Chief Executive's Report
PT8TT134

Part VIII Development

Birdhill Active Travel Scheme

November 2024

Figure 4: Description of Movements Assessed in Junction Modelling Exercise

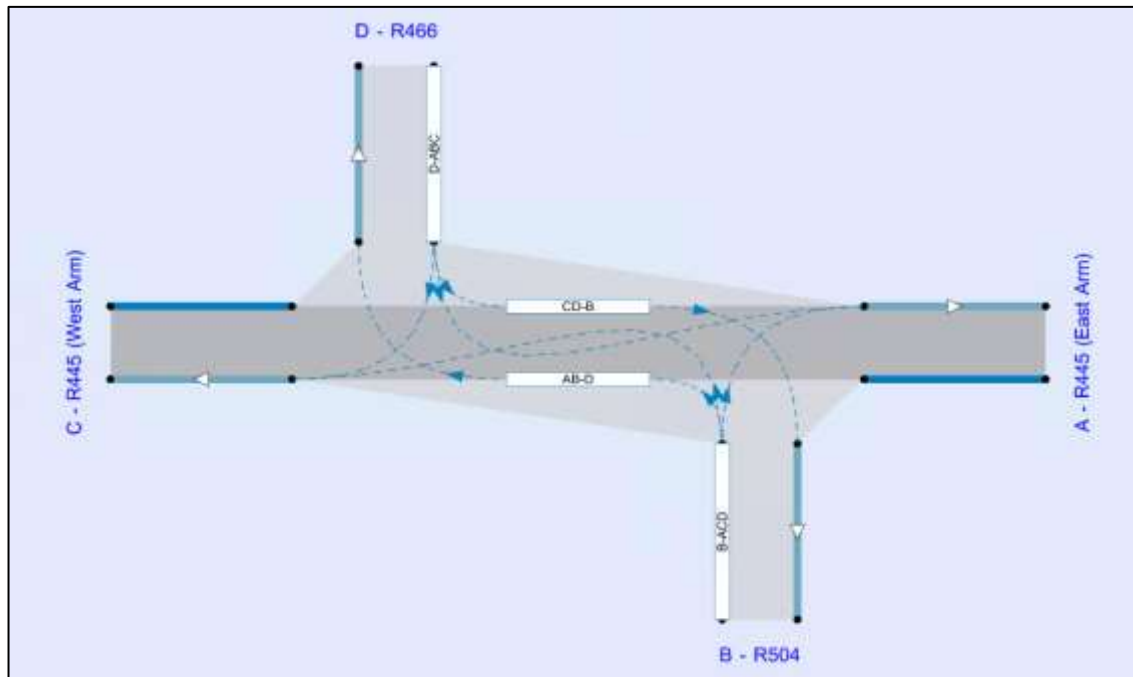
To provide further assurance that the removal of the central island along the R445 will not result in queuing or capacity issues, a traffic modelling exercise was undertaken using the Transport Research laboratory (TRL) Computer Package PICADY for priority-controlled junctions. This assessment was undertaken at the R445 / R466 (W) / R504 (E) staggered priority-controlled junction. The existing arrangement of this junction was modelled, as well as the proposed arrangement as per the Birdhill Active Travel Scheme. A summary of the two models (indicative schematic shown in **Figure 1**) include:

The comparison between the existing and proposed junction arrangements shows minimal differences in queue lengths, delays, and ratios of flow to capacity (RFC). In the AM peak, vehicles exiting the R504 (Stream B-ACD) experience a modest delay increase from 8.66 to 9.48 seconds. The RFC also remains very low, increasing only marginally from 0.25 to 0.27 for this same movement. Similarly, the right turn from R445 to R466 (Stream AB-D) sees negligible changes in both queue length and delay. The results show that the proposed scheme maintains efficient traffic flow, with no significant changes to vehicle queue lengths or driver delays.

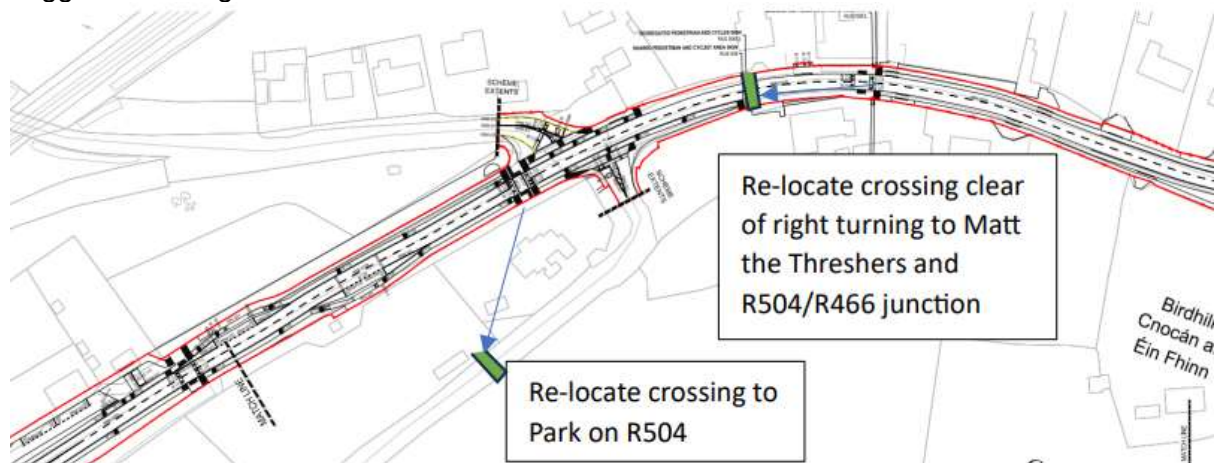
Ref. No.	Date received	Submission Name and Address
3.	21/9/2024	Freda Gleeson, Kaukauna Lodge, Birdhill, Co. Tipperary
<p>Summary</p> <p>The submission outlines hazards and requests that same are addressed:</p> <ol style="list-style-type: none"> 1. The scheme proposes a mixed footpath/ cycle environment in the middle of the village, at the interface with Matt the Threshers restaurant, Trading Centre Coffee shop and Coopers Public house. This creates a serious threat to pedestrian safety in terms of risk of collision between pedestrians and cyclists on the mixed footpath. This is the area where the greatest interaction occurs and cycle and pedestrian lanes should be separated. 2. The removal of the right turn lane and traffic separation island throughout the village centre. This introduces a significant safety hazard to traffic movement which the current road arrangement addresses. This seems a design flaw in compromising the safety of traffic movements, which ultimately put cyclists and pedestrians at greater risk, including increasing significantly the risk to motorists themselves turning right in the village. 3. The introduction of the cycle lane running across numerous entrances for houses, commercial properties, and other properties, and the main Newport R504, O'Briensbridge R466 intersection, this scheme places an inside blind spot hazard of colliding with cyclists in the most vulnerable way for serious cyclist accidents, particularly where large vehicles and trailers are turning left. The cycle lane design would encourage a cycle path right of way on the inside of left turning traffic, and also a conflict on cyclists turning right (which happens a lot in relation to the R504/ R466 intersection and entrances to commercial properties), as they have no lane for turning right. It is notable also that the village is used significantly by cycle groups and pelotons. These groups do not travel in single file and will actually require use of the entire carriageway for safety of manouver and passage, thus rendering the single cycle lane inadequate for the majority of cyclists that use the village. 4. Regarding the submitters own property the new traffic Island and restricted centre lane at the R445 and R466 junction for turning will make it less safe for traffic entering and exiting their property. <p>In order to address the above the submission requests:</p> <ol style="list-style-type: none"> 1) The cycle lanes proposed terminate at the entrance to the reduced speed limit for the village on both Limerick and Nenagh approaches. 2) That the existing centre lane for traffic separation and right turns, along with existing grade separated footpaths are preserved as is, inside the village speed limits, and particularly in the commercial centre of the village and no mixed footpaths be created here. 3) Cyclists and motorists approaching the village should be encouraged to use the existing carriageway once they reach the speed limit and observe each other directly in lane, ensuring full visibility and understanding of right of way and intended movement and maneuvers, rather than creating a dual carriageway behaviour where inside passing and right of way would lead to confusion and danger. 4. The proposed pedestrian crossings should not be intersected by both vehicle and cycle lanes, and should remain as simply a two lane carriageway with centre island reservation crossing arrangement. This would allow pedestrians crossing to have a safe refuge in the centre of the road and focus on directional traffic in each separate lane. 5. Remove crossing at the Newport / O'Brien bridge Road intersection noting pedestrians heading to the Park or further up the Village from the Railway Station or vice versa are better served by other crossings, with pedestrian movements close to this crossing being very limited

in need but far more difficult for motorists and pedestrians to navigate. See layout below with suggested changes.

1. The proposed works represent a standard approach widely utilised and recommended in the Cycle Design Manual. The shared pedestrian / cycle path approach, as utilised extensively on the emerging Killaloe Bypass, Shannon Bridge Crossing and R494 Improvement Scheme; also negates the need to utilise / incorporate private lands as located along the frontage of (a) 'Matt the Threshers Restaurant, (b) Trading Centre Coffee Shop, and (c) Coopers Public House. Patrons of all three businesses are not required to utilise the proposed 'shared path' when traveling to/from the business car parks as located to their rear and access via dedicated private footpath / route. The scheme proposals retain the existing boundary treatments at each of these three businesses which provides a formal segregation and minimises the potential for any interaction between the businesses patrons and users of the 'shared' path. The scheme proposals have been subject to an independent Road Safety Audit and no issues with the proposed Shared pedestrian cycle path arrangements in the centre of the scheme have been raised.

3. The concern regarding cyclist safety is noted. The scheme proposals advocate separating cyclists from motor vehicles on carriageway by means of a segregated cycle track with a kerb (bevelled at vehicle crossing points) that runs along the majority of the length of the R445 within the study area. This design approach gives cyclists their own priority on the road space and provides a physical separation from motor vehicles, thereby increasing safety for cyclists. The proposed road carriageway width reduction to a minimum of 6m, along with the visual impact that cycle tracks provide to drivers, induces a slow-speed environment for vehicular traffic. This results in vehicles turning onto / off the R445 to proceed with caution and at lower speeds. Slower speeds allows drivers to have a better perception of their surroundings, ultimately reducing the potential of collisions. The proposed design addresses a number of existing road safety issues and complies with the recommendations of both the Cycle Design Manual and DMURS. The design represents the new layout reflecting recently published design standards that will in time become the norm along all key active travel corridors.

The introduction of the traffic / refuge islands have been proposed to (i) address existing excessive speeding issues observed by vehicles turning off the R445 corridor into both minor arms, (ii) address inappropriate 'fast line' routing (across the opposing inbound traffic lane on the minor arm) of some vehicle drivers turning into the minor arm, and (iii) to provide a refuge for active travel users crossing the mouth of the minor arm. The proposed junction design has been influenced by the vehicle swept

path requirements of the adopted design vehicle. Accordingly, the design team has undertaken a swept-path analysis for all vehicle movements through the R445 / R466 / R504 junction. The design vehicle used was an HGV (articulated vehicle) with a length of 16.5m and a width of 2.55m. The design associated with the R445 / R466 (W) / R504 (E) junction within this Scheme is based on the swept path for such an HGV. The swept path analysis indicates there is sufficient space for an HGV to manoeuvre through the junction. Accordingly, the design therefore incorporates best practice guidance as per the NTA's Cycle Design Manual (September 2023) and DMURS which prioritises safety of road users, yet continues to accommodate the requirements of the largest design vehicle.
